MIL-PRF-19500/528A
AMENDMENT 1
14 November 2002

PERFORMANCE SPECIFICATION SHEET

SEMICONDUCTOR DEVICE, TRANSISTOR, NPN,
SILICON, POWER, TYPES 2N6032 AND 2N6033
JAN, JANTX, AND JANTXV,

FIGURE 2. $V_{(BR)CEO}$, $V_{(BR)CER}$, $V_{(BR)CEX}$ measurement circuit."

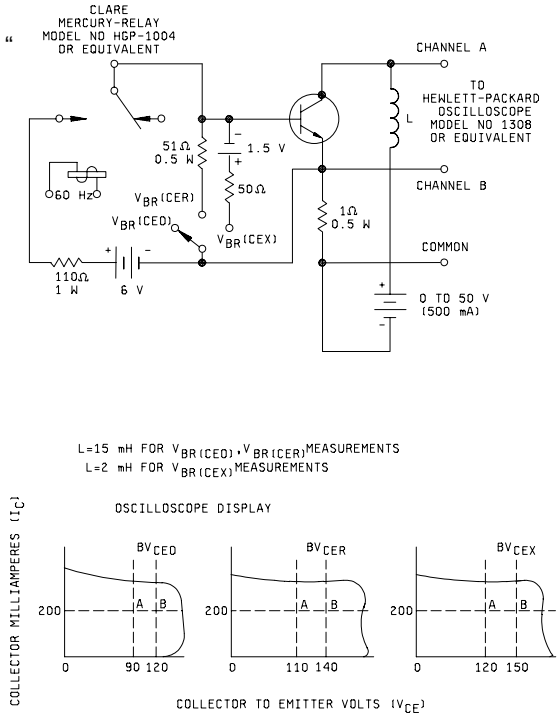
FIGURE 2, delete and substitute:

NOTE:
$V_{(BR)CEO}$, $V_{(BR)CER}$, $V_{(BR)CEX}$ is acceptable when the trace falls to the right and above point "A" for type 2N6032. The trace shall fall to the right and above point "B" for type 2N6033
